AGENDA OF THE PLANNING BOARD

June 9, 2022

DELAVERGNE AVENUE SUBDIVISION

Please find below our responses (**in bold**) to the Town of Poughkeepsie February / March 2022 comment letters from all departments for the project.

1 SIGHT DISTANCE
 1" = 20'

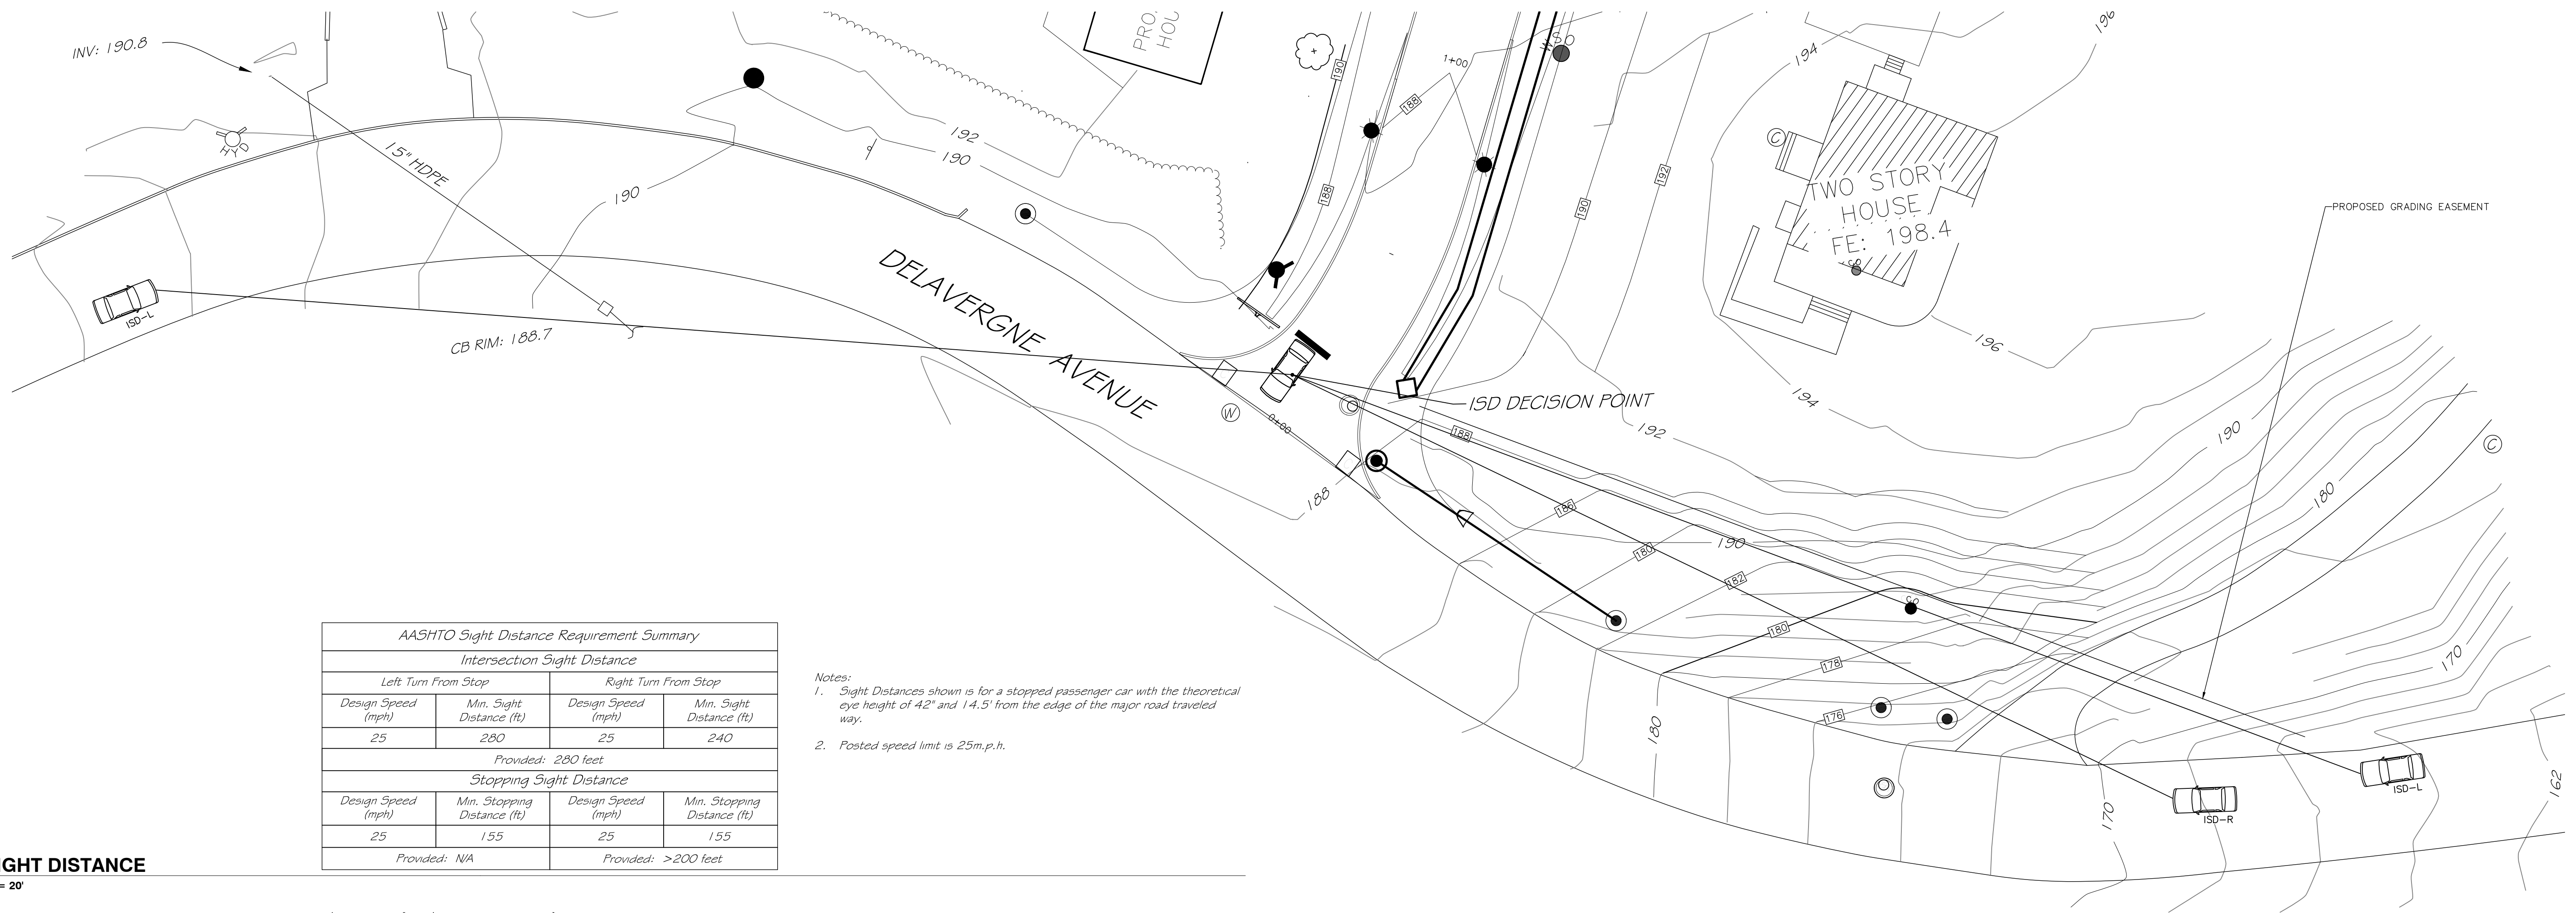
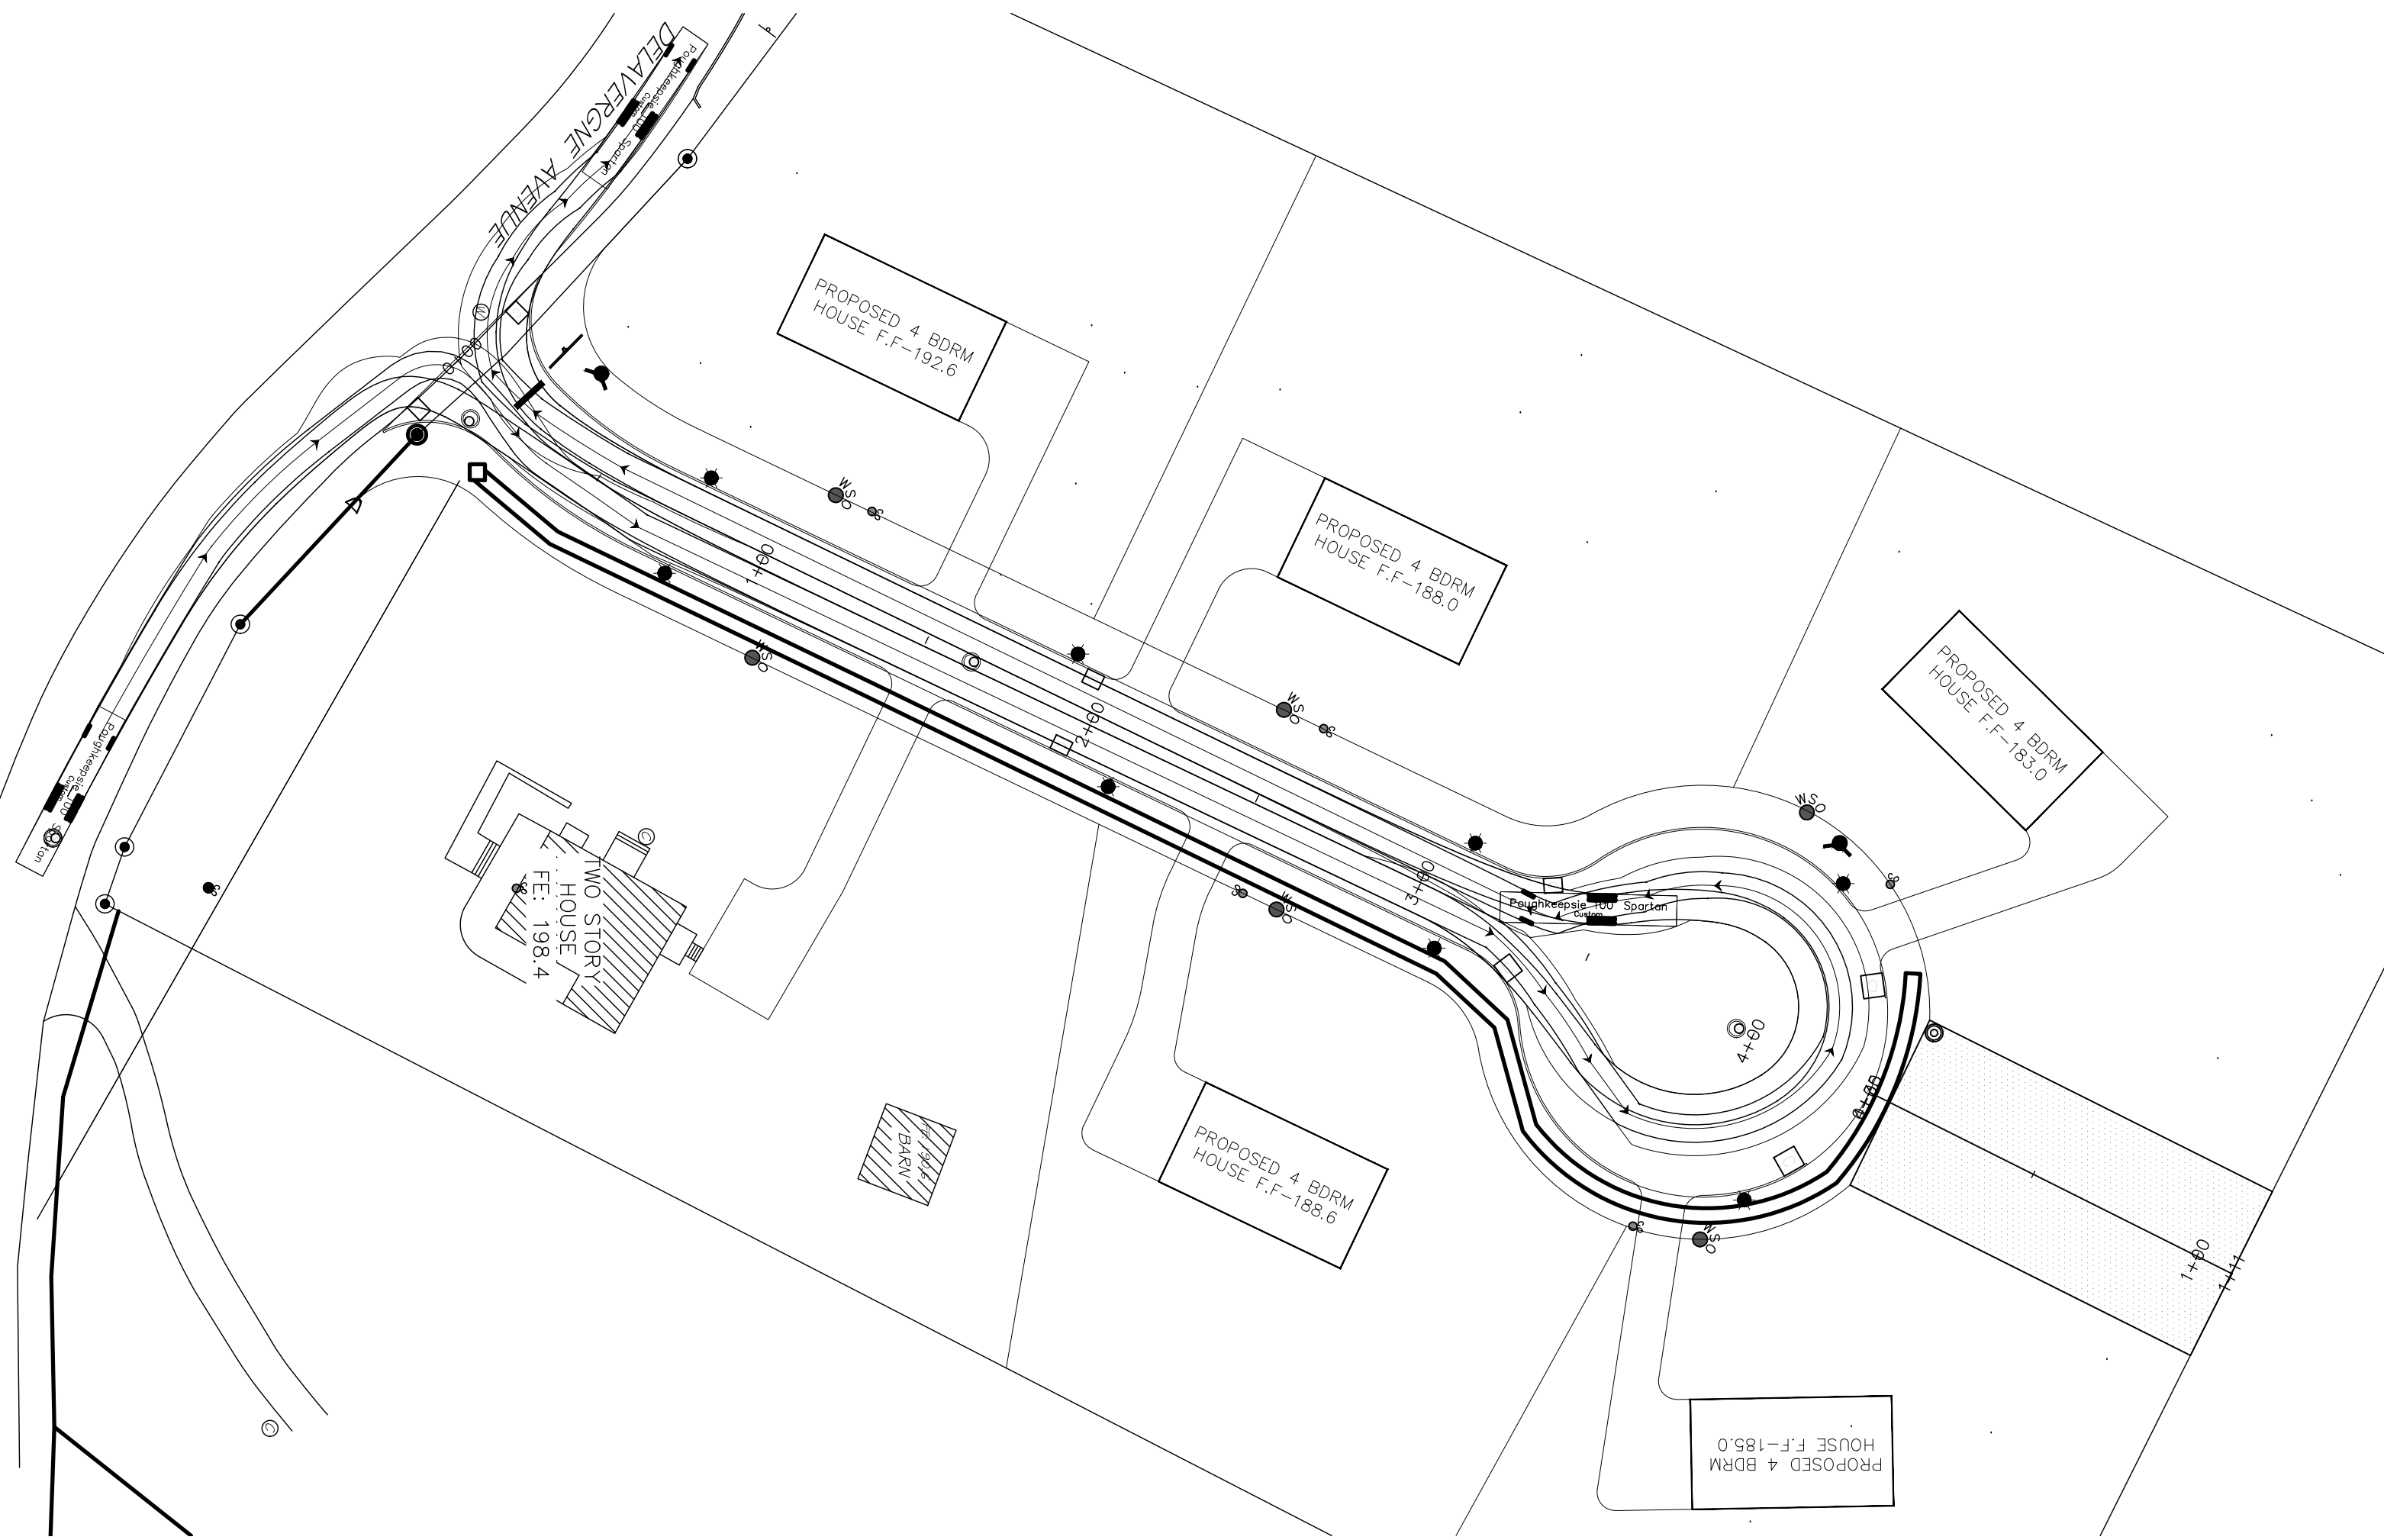
16. *As previously stated, Rolled Erosion Control Fabric will be required for all slopes that are steeper than 3(H):1(V). The proposed grading on Lot 1 to provide sight distance appears to require erosion control fabric.*

2 WATER & SEWER SEPARATION
NOT TO SCALE

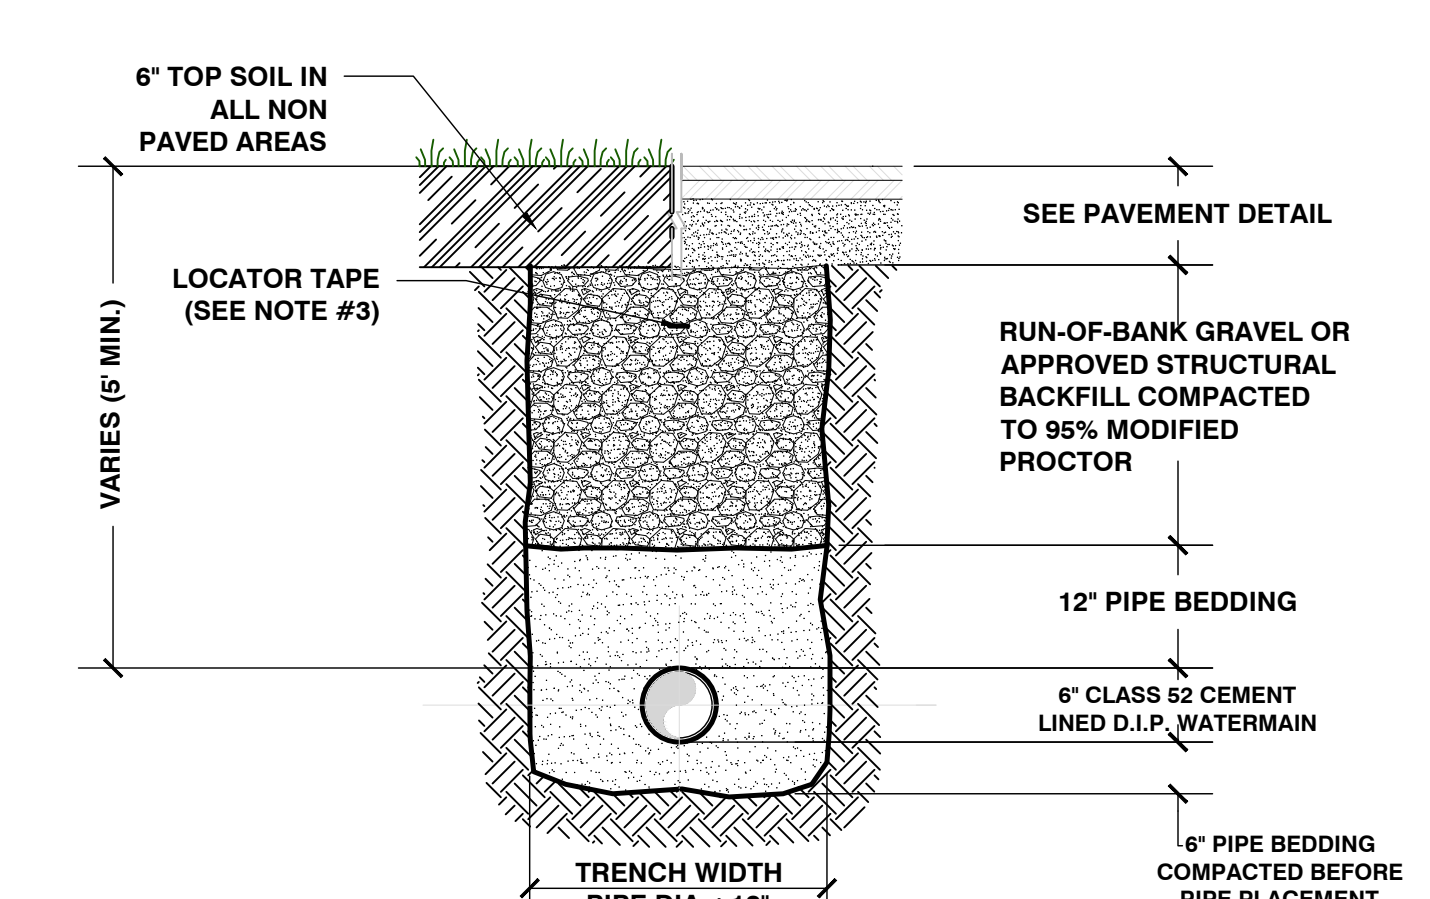
*on the water details page 8, modify water and sewer separation note #4 by eliminating any suggestion of concrete or k-kreat for any encasement of pipe. **Removed** service line note one should state that corporation taps will be installed at the 12 o'clock position, **Revised** and note #14 should state that service lines 100' or longer, require the use of 1" copper tubing. **Revised** The utility plan should show the extension of the Delavergine avenue water main .the town's water main ends at the fire hydrant. In front of the Deleno property. The antique hydrant in front of your proposed subdivision is of unknown origin. **The main is being extended from the Town. The hydrant is to be replaced and relocated. The main is labeled as an 8" diameter.***

7 LIGHT POLE BASE DETAIL
NOT TO SCALE

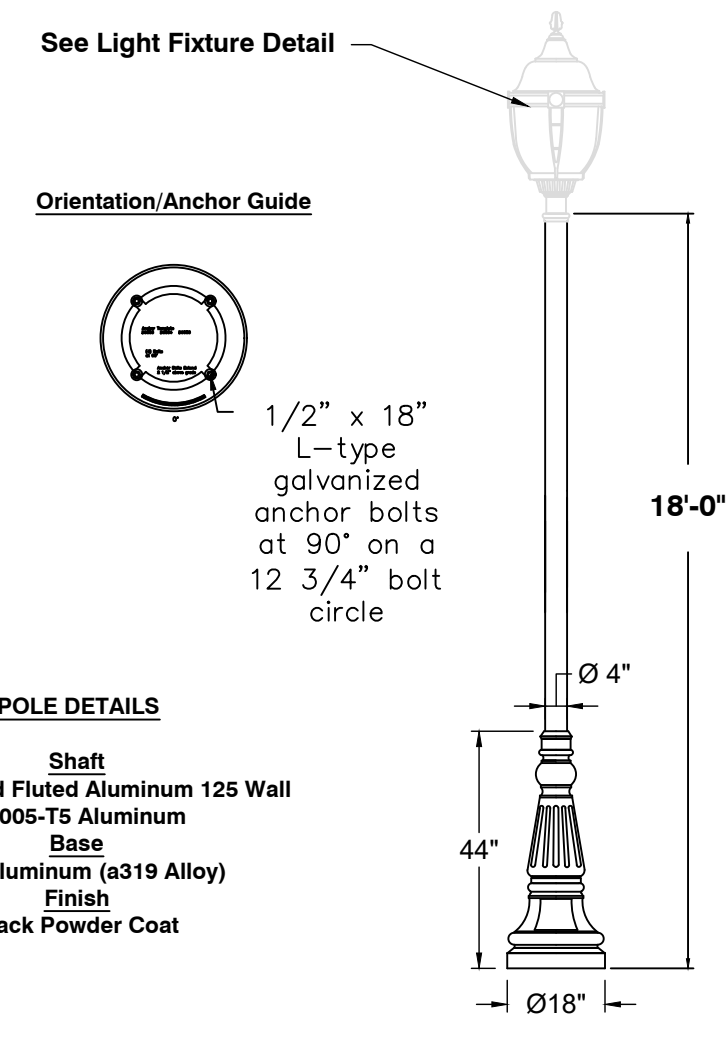
14. *Response to prior Comment No. 23 is noted. As previously stated, details for light pole bases and fixtures must be included in the plan set. All fixtures must be dark skies compliant and designed to prevent glare into adjoining structures.*
